Re: Draft Final Remedial Design and Remedial Action Work Plan, LHAAP-04 Former Pilot Wastewater Treatment Plant, Longhorn Army Ammunition Plant, Karnack, Texas, April 2019

**Response to Comments on
Draft Remedial Design / Remedial Action Work Plan
LHAAP-04 Former Pilot Wastewater Treatment Plant,
Longhorn Army Ammunition Plant, Karnack, Texas**

Comment Date: 5 March 2019

Comment Date: 12 March 2019

Figure 4-1

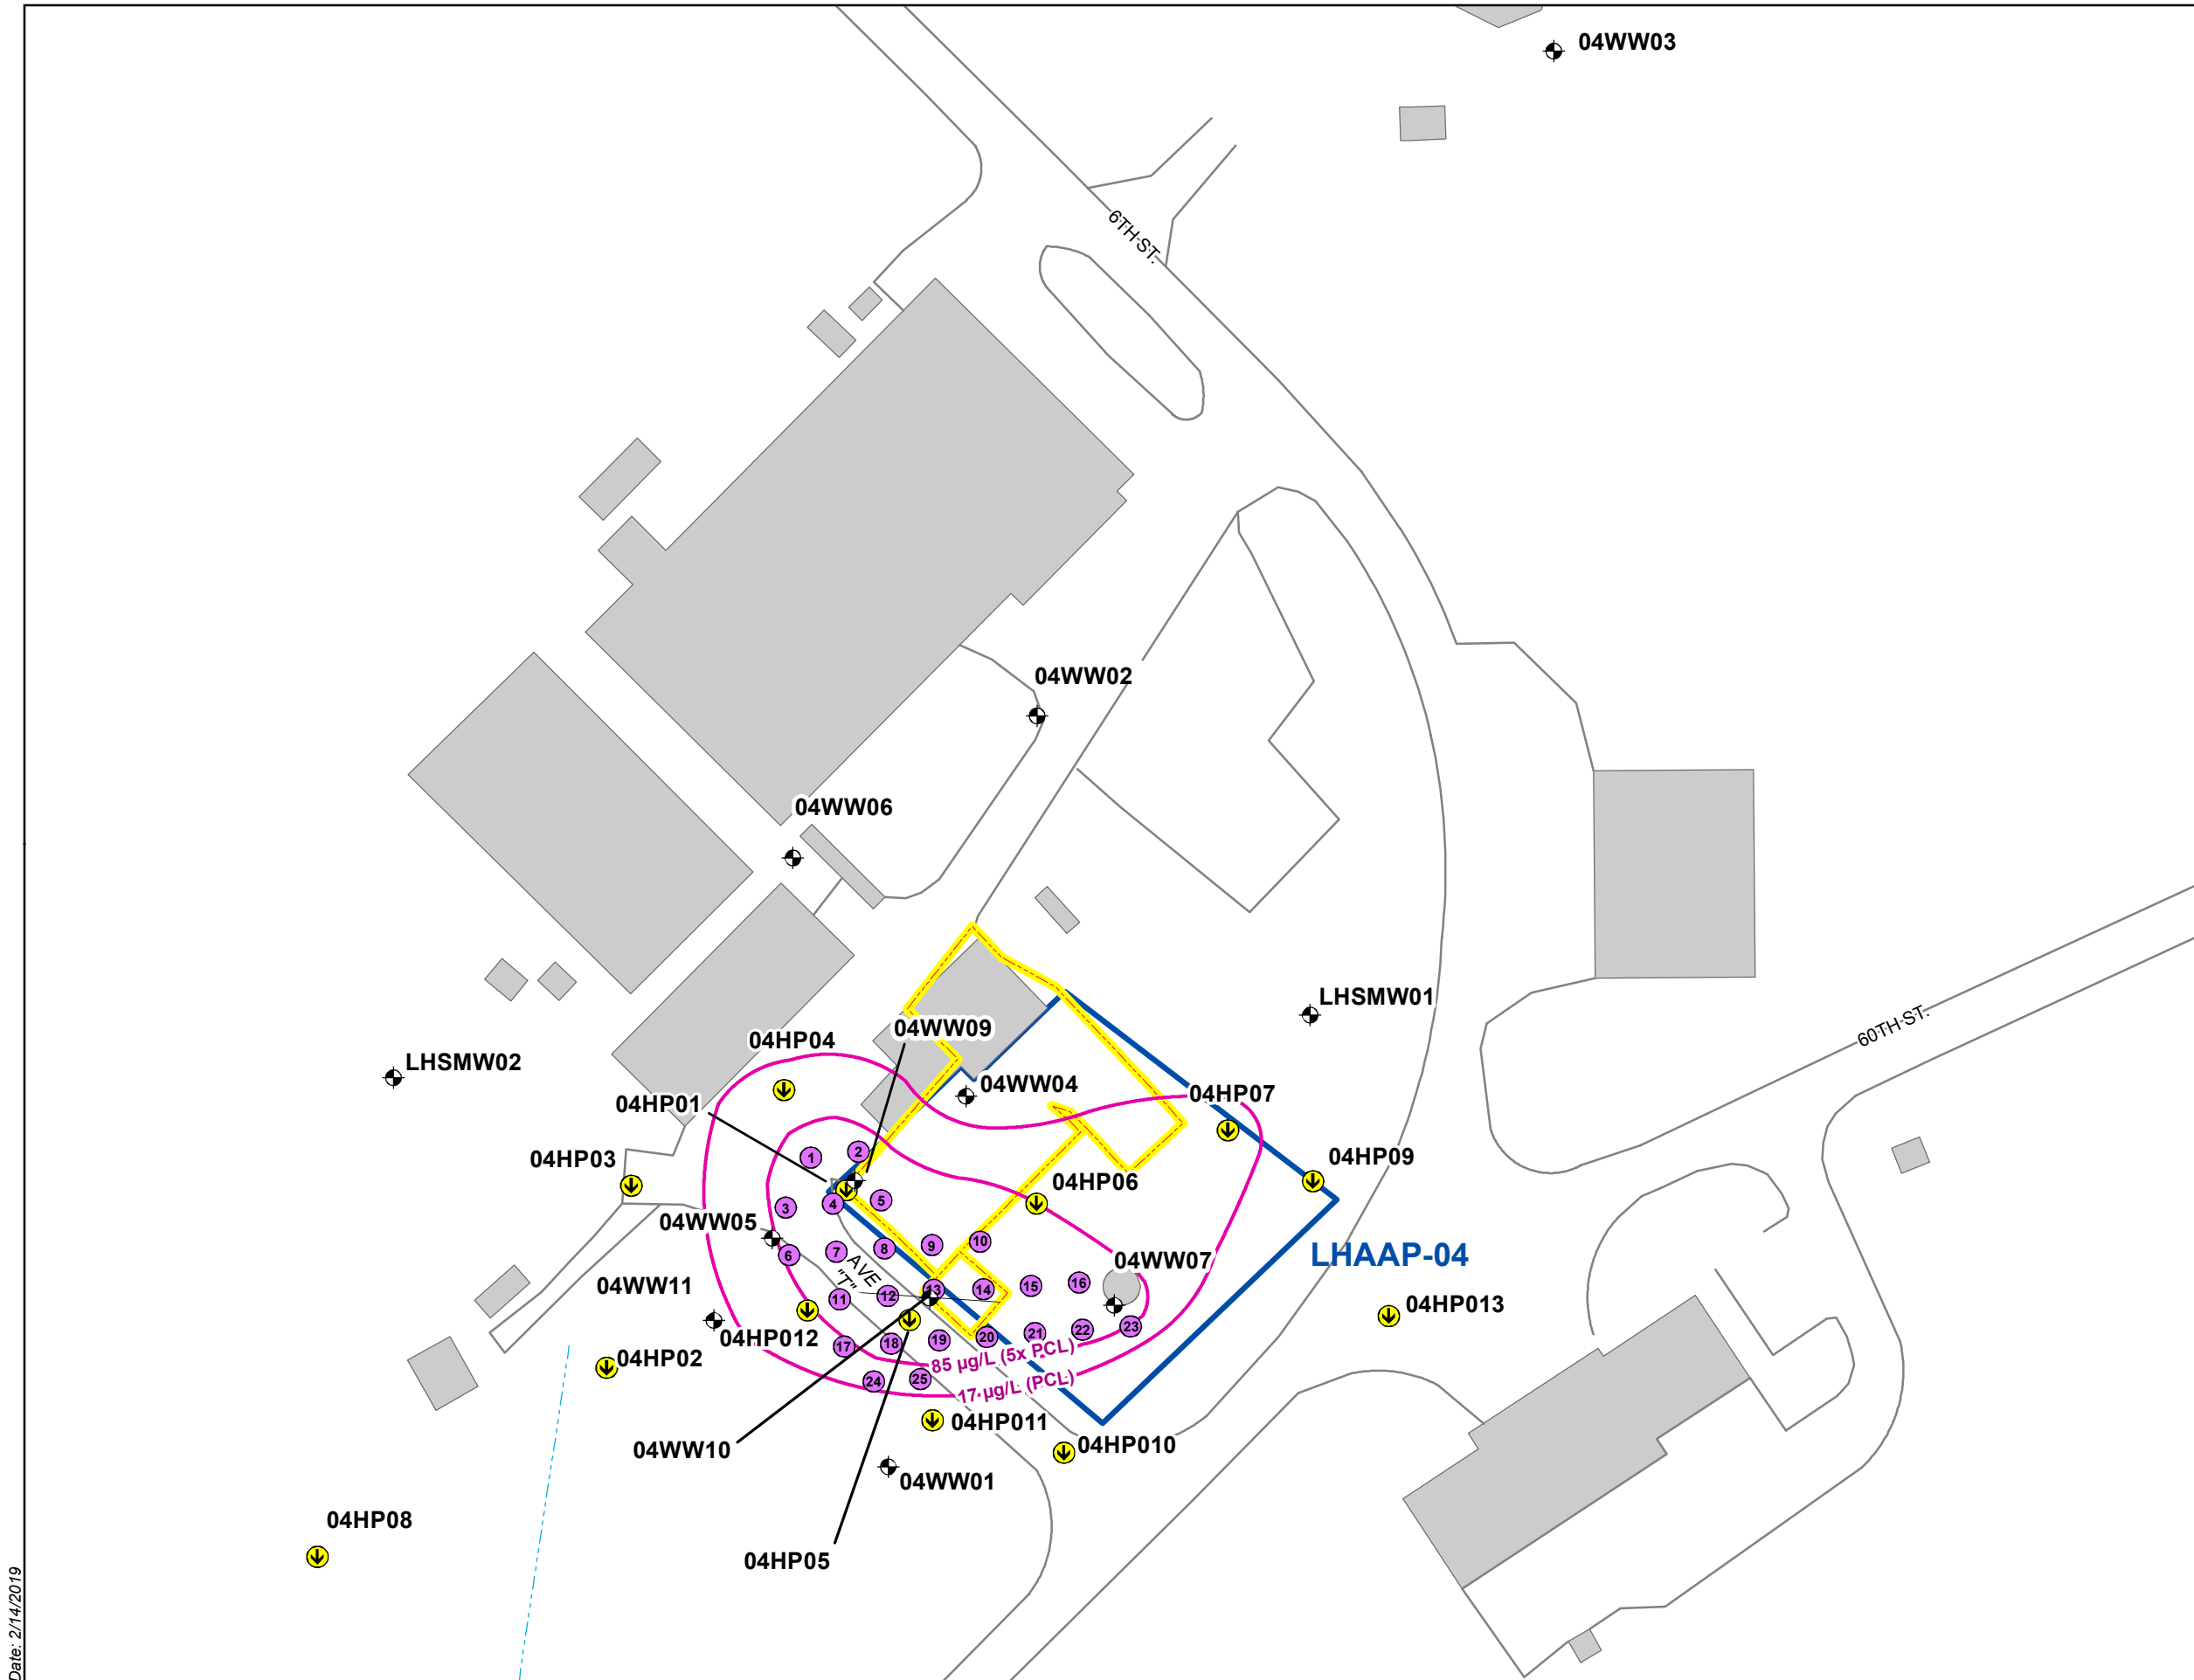
3.	Figure 4-1	The LUC boundary should be larger than indicated on the figure if you consider the perchlorate contamination found in 04WW05 and 04HP012.	C	The Army and USFWS will coordinate revision of the LUC boundary to reflect the plume expansion beyond the Army property line onto the refuge. The revised LUC boundary will be published in the Response Action Completion Report. The process described in Section 4.1 will be followed to implement and record the revised LUC boundary.

3.	Figure 4-1	LUC boundary doesn't include the entire plume.	C	The Army and USFWS will coordinate revision of the LUC boundary to reflect the plume expansion beyond the Army property line onto the refuge. The revised LUC boundary will be published in the Response Action Completion Report. The process described in

Comment No.	Section, Page ref.	TCEQ Comment	C, D, E, or X ¹	Response	A or D ²
				Section 4.1 will be followed to implement and record the revised LUC boundary.
